The following Addendum forms part of the Contract Documents for Project R.076516.013. The following changes, additions or deletions shall be made to the following documents as indicated and all other Contract Documents shall remain the same.

This Addendum Number 01 contains 8 written pages, and 44 attachments as follows:

441 UNIVERSITY RECAPITALIZATION

441 UNIVERSITY AVENUE
WINDSOR, ON

DRAWING NO: ASK-001

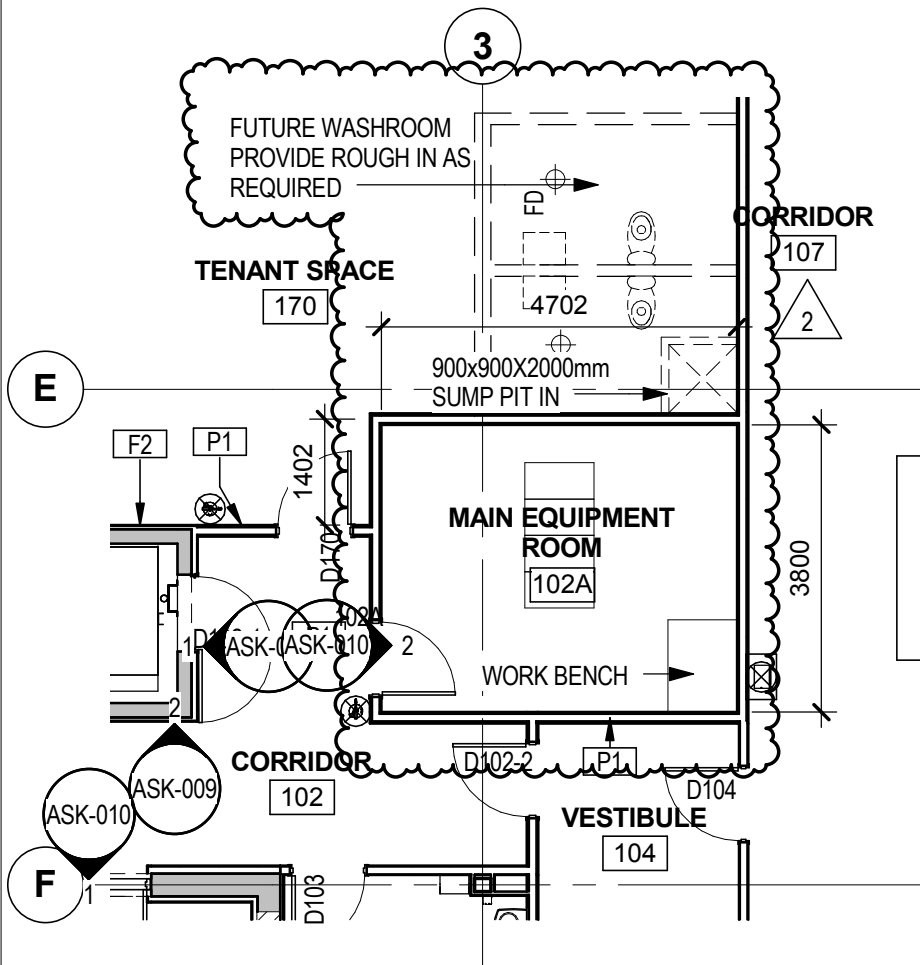
- .1 Revise as shown in Sketch ASK-001, attached and forming part of this addendum.

DRAWING NO: ASK-002

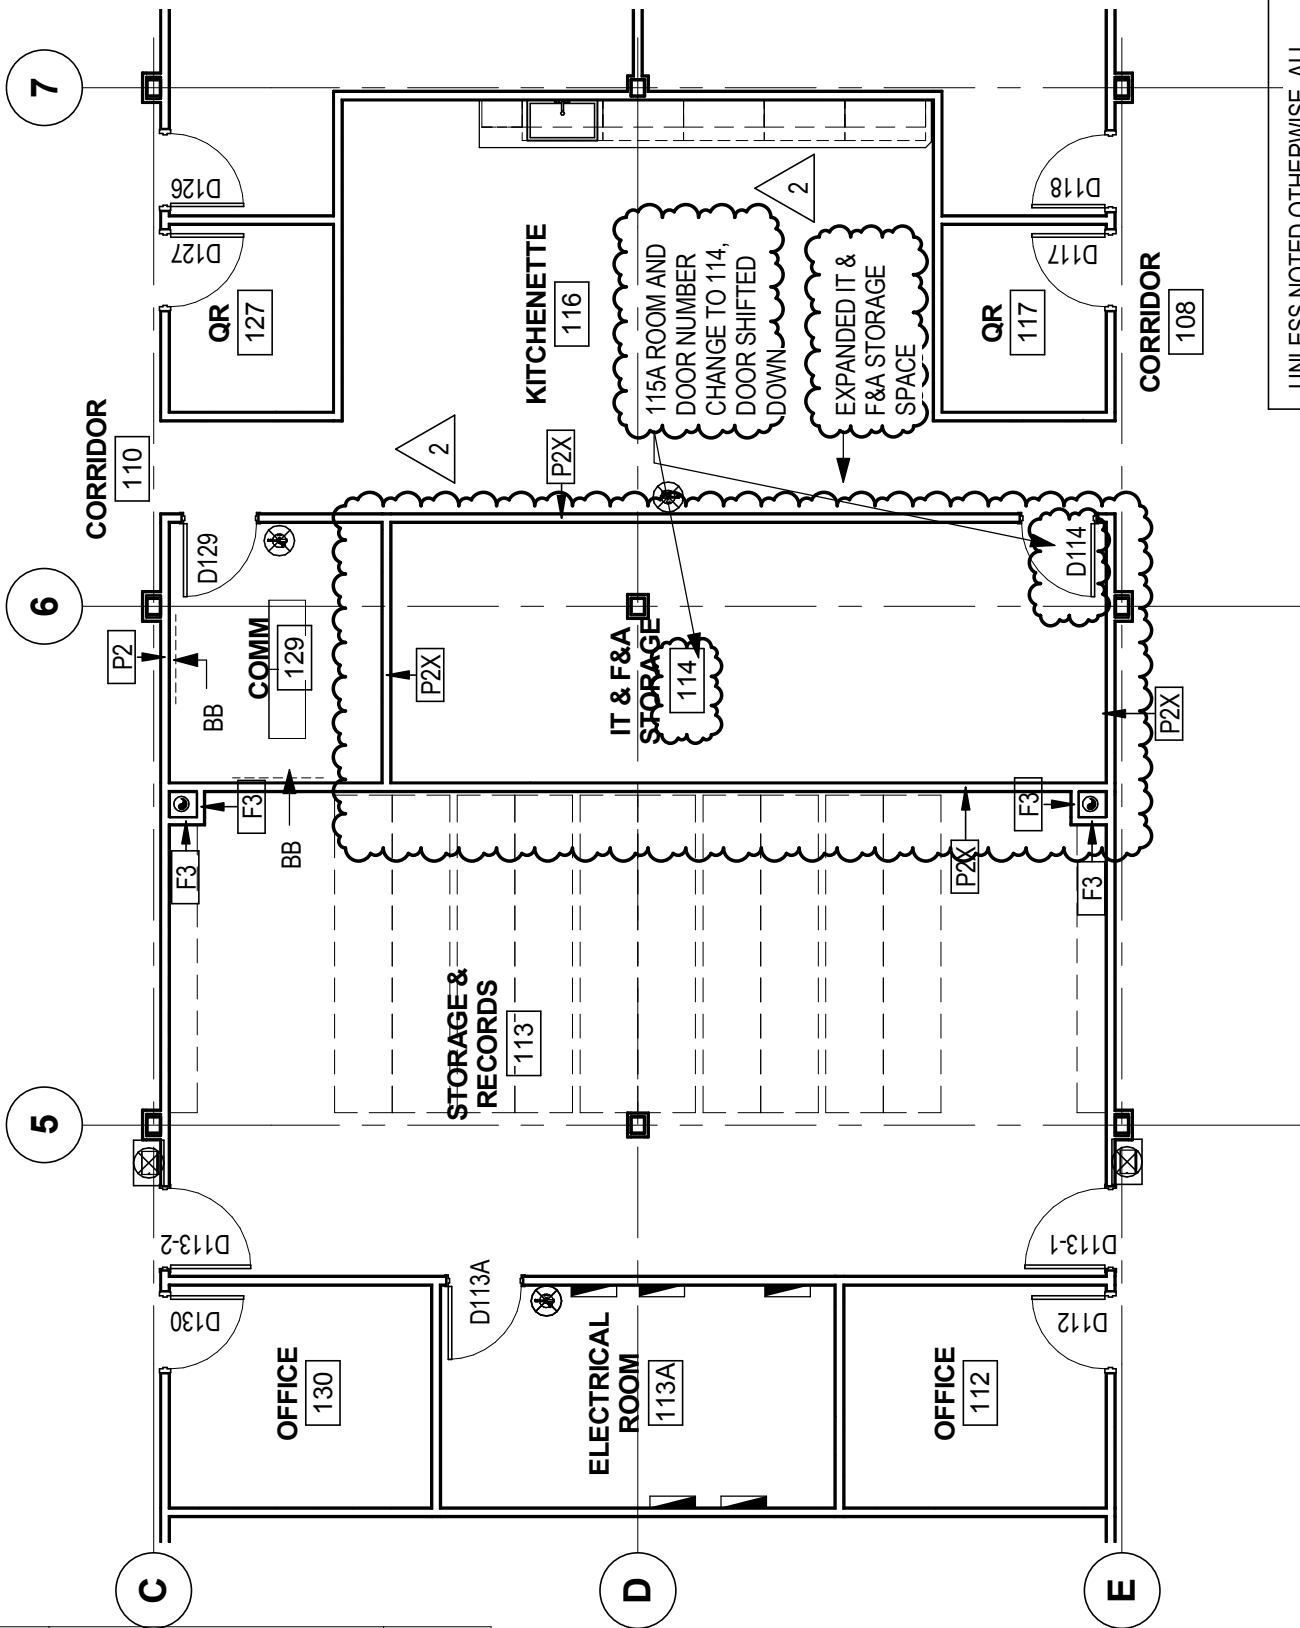
- .1 Revise as shown in Sketches ASK-002 and ASK-003 attached and forming part of this addendum.

DOOR (D102A) - 965x2135mm, TYPE D2, HM,
PAINTED, F1 HOLLOW METAL PAINTED
FRAME, J1 JAMB, #02 HARDWARE LOCKSET,
WITH ACCESS CONTROL AND DOOR
CONTACT

DRAWING NO: ASK-007

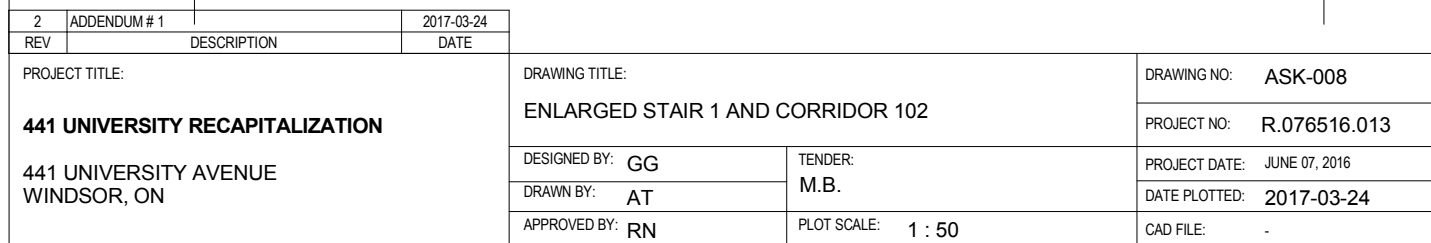
MEETING ROOM 121 AND MEETING ROOM 209 TO HAVE 12 FLOOR OUTLETS IN EACH ROOM,
DEPARTMENTAL REPRESENTATIVE TO CONFIRM LOCATIONS

DRAWING NO: ASK-009

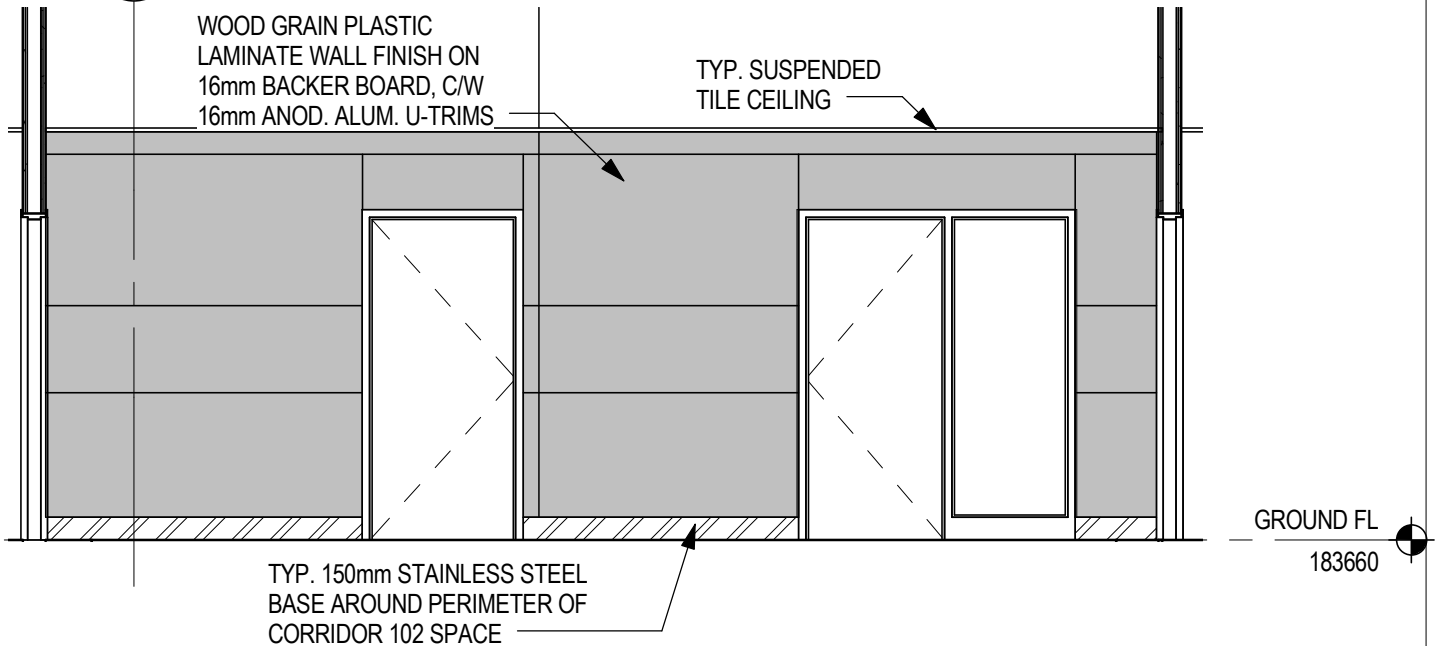
- .1 Detail 4/A9.03; Revise as shown in Sketch ASK-010, attached and forming part of this addendum.
- .2 Detail 5/A9.03; Revise as shown in Sketch ASK-009, attached and forming part of this addendum.
- .3 Detail 6/A9.03; Revise as shown in Sketch ASK-009, attached and forming part of this addendum.
- .4 Detail 7/A9.03; Revise as shown in Sketch ASK-010, attached and forming part of this addendum.
- .5 Detail 8/A9.03; Revise as shown in Sketch ASK-008, attached and forming part of this addendum.

NOTE: WALL FINISHES WITHIN ALL INTERIOR
WALLS OF CORRIDOR 102 TO MATCH
DETAILS 4/9.03 & 5/A9.03

DRAWING NO: **ASK-011**

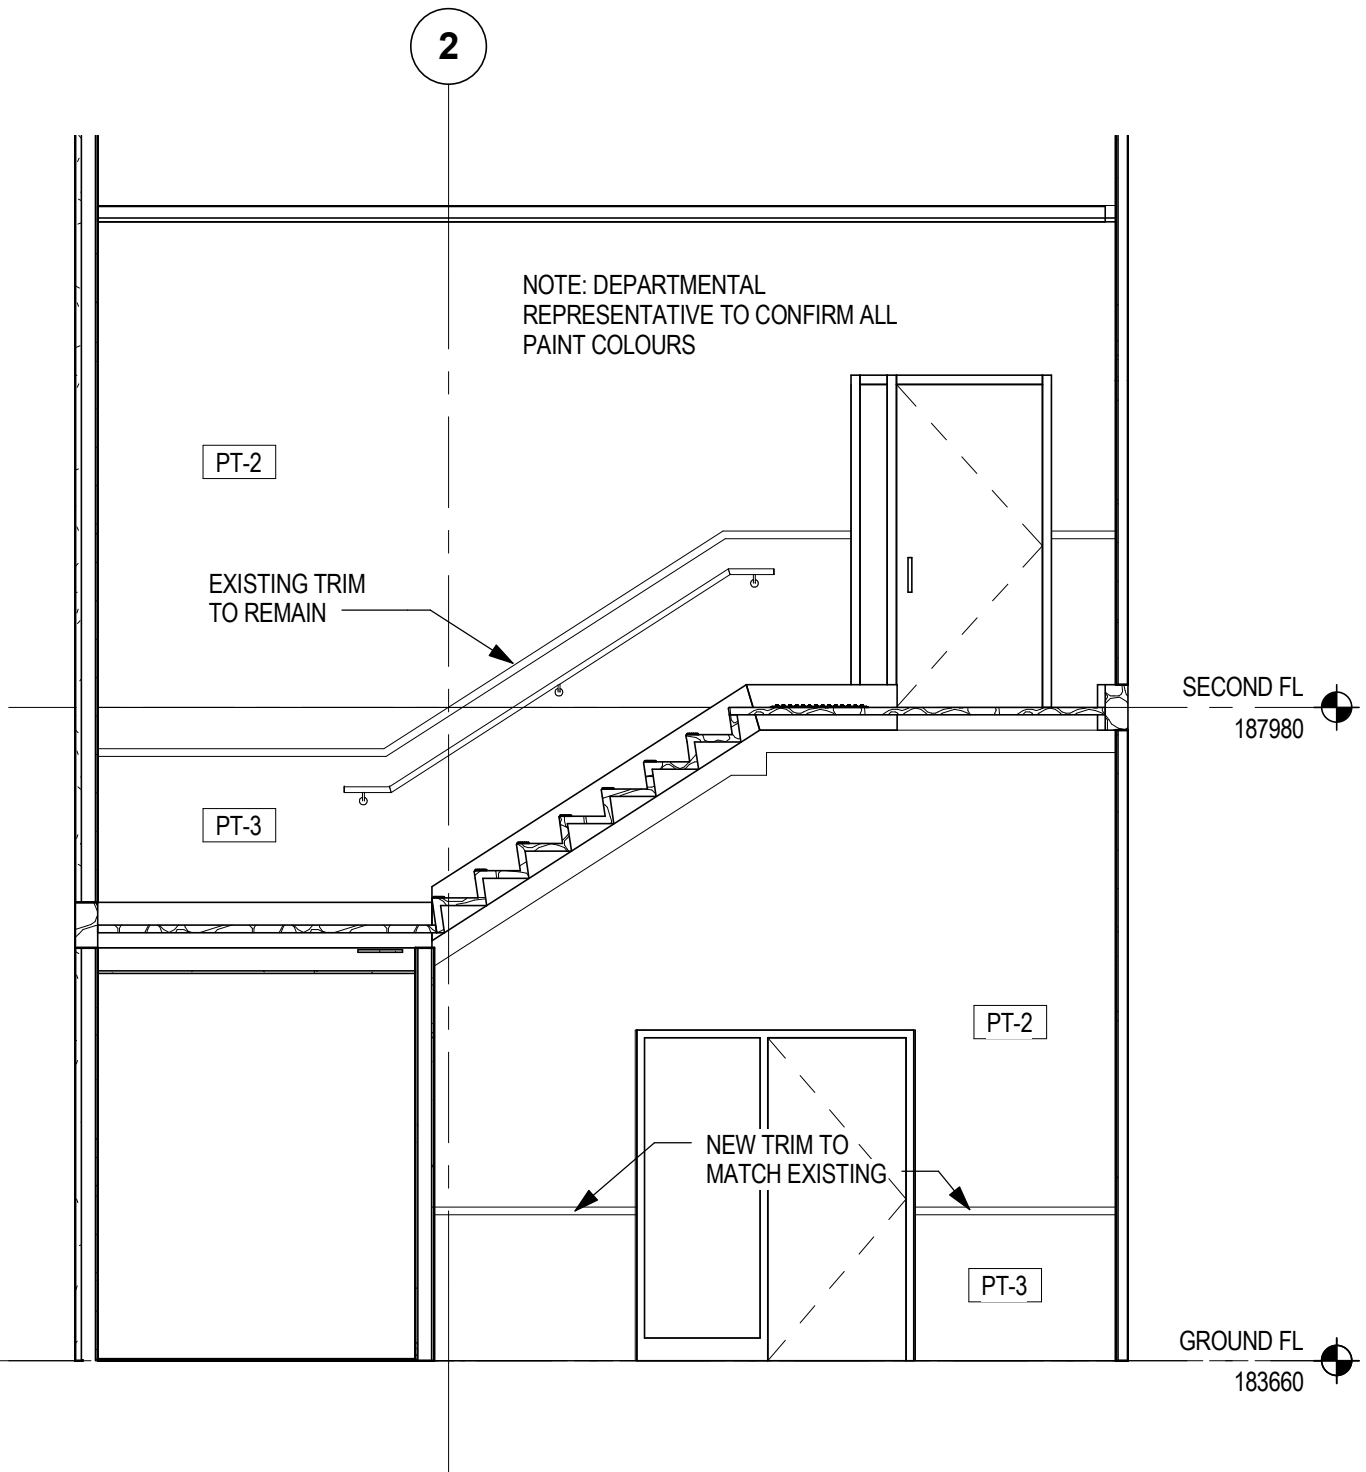
- .6 Detail 9/A9.03; Revise as shown in Sketch ASK-014, attached and forming part of this addendum.
- .7 Detail 10/A9.03; Revise as shown in Sketch ASK-013, attached and forming part of this addendum.
- .8 Detail 11/A9.03; Revise as shown in Sketch ASK-012, attached and forming part of this addendum.
- .9 Detail 12/A9.03; Revise as shown in Sketch ASK-011, attached and forming part of this addendum.
